## **STAFF REPORT**

**LOCATION:** 100 Lynn Darr Drive (APN 372-323-001)

**PROPOSAL:** Public hearing to consider a proposal to construct a new single-family residence on a vacant hillside parcel. The applicant is requesting Design Review approval; exception to building height limitations to allow a building height of 33 feet, where a maximum of 25 feet is permitted; and a variance to allow retaining walls greater than 6 feet high within minimum front and side yards.

Approve Use Permit #09-05, Variance #09-03, and Design Review #09-24 subject to the attached conditions of approval.

○ SOUTH ELEVATION RENDERING  
1/4"=1'-0"

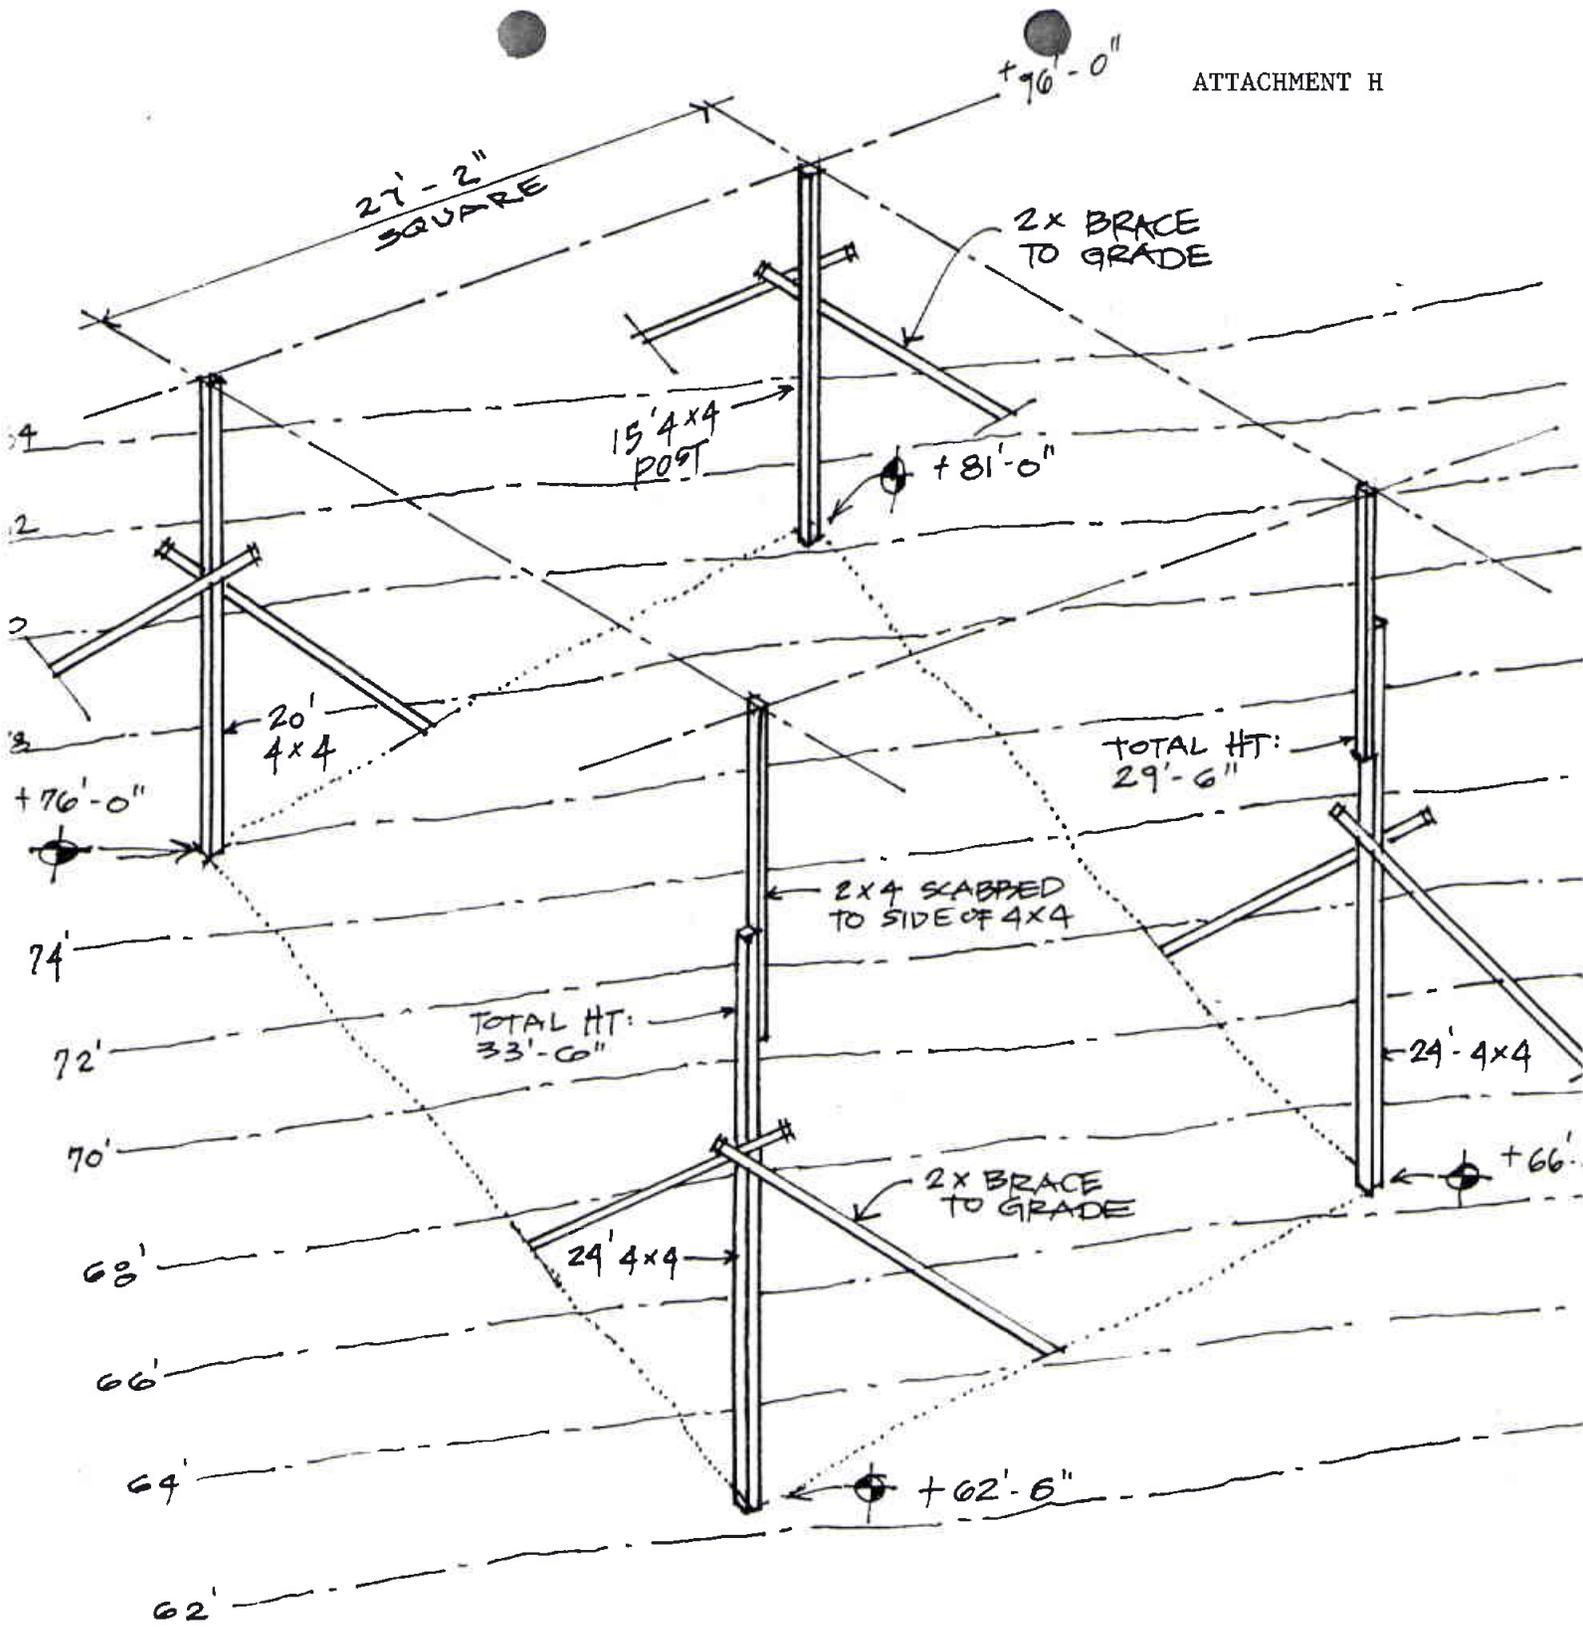
Study off-site views, especially down along Berrellessa. Provide story-poles, provide landscape plan, showing accurate tree removal and tree mitigation proposals. Study reflective glass on East/South Sides.

- LOOK A REVISIONS EXTENSION MATERIALS AND MINIMIZING GLAZING.
- ADD STORM POLES TO SHOW HT. OF PROPOSED STRUCTURE.
- DEVELOP PHOTO SIMULATION FROM LOWER VIEWPOINTS
- CONSIDER ADDING TALL TREES IN FRONT OF PROPERTY TO MITIGATE STRUCTURE HT.

- **Exterior Colors and Materials:** The applicant has chosen an appropriate limited palette of exterior colors and has revised proposal to include less glazing and more wood siding (see enclosed color elevation renderings).

**Character:** As noted above, the use of horizontal cedar siding has been increased to promote the residential character of the proposal. We also believe reducing the height and mass of the original proposal lends more residential character to the project. The overall 'natural contemporary' aesthetic of the building, however, remains relatively unchanged. We submit that a well crafted and finely detailed building in such a setting is inherently residential, even though it may exhibit contemporary aesthetic sensibilities. To this end, we have not changed the material of the stair tower, as we believe that a quality integral color smooth troweled cement plaster siding system is an appropriate choice for this building component.
